### AEC DISTRIBUTION FOR PART 50 DOCKET MATERIAL (TEMPORARY FORM)

Re: Oconee Nuclear Station
Docket Nos. 50-269, 270, -287

Section 6.1.1 of the Oconee Nuclear Station Technical Specifications, Appendix A to Facility Operating Licenses DPR-38, -47, and -55, specifies the organization of Oconee Nuclear Station. Pursuant to 10CFR50.59, it is requested that the Oconee Nuclear Station Technical Specifications be revised to show:

FIGURE 6.1-1

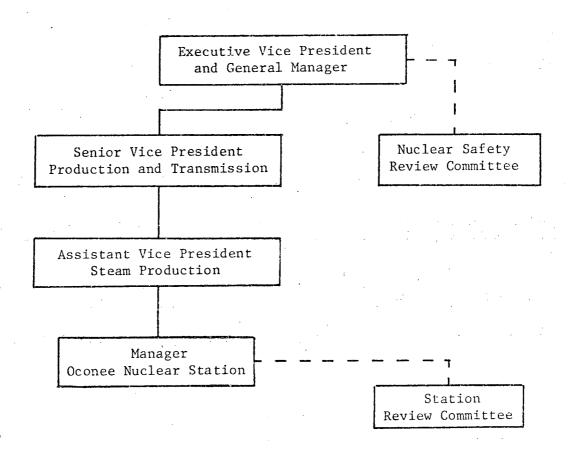
- 1. Title changes within the station organization such as Superintendent to Manager, Technical Support to Technical Services, etc.
- 2. Changes to the station organization chart, Figure 6.1-1.

Section 6.1.1.3 of the Oconee Nuclear Station Technical Specifications, Appendix A to Operating Licenses DPR-38 and DPR-47, states that the station organization for operation, technical support, and maintenance shall be functionally as shown in Figure 6.1-1, "Station Organization Chart". It is requested that Figure 6.1-1 be revised as shown in Attachment 1.

Significant changes in the station organization, proposed in Attachment 1, are as follows:

- 1. Instrumentation and control personnel will be moved from the Technical Support Group and will report to an Instrument Engineer who reports to the Maintenance and Instrument Engineer.
- 2. Health physics personnel will report to a Health Physics Supervisor and chemistry personnel will report to the station Chemist. Both supervisors report to the Technical Support Engineer.
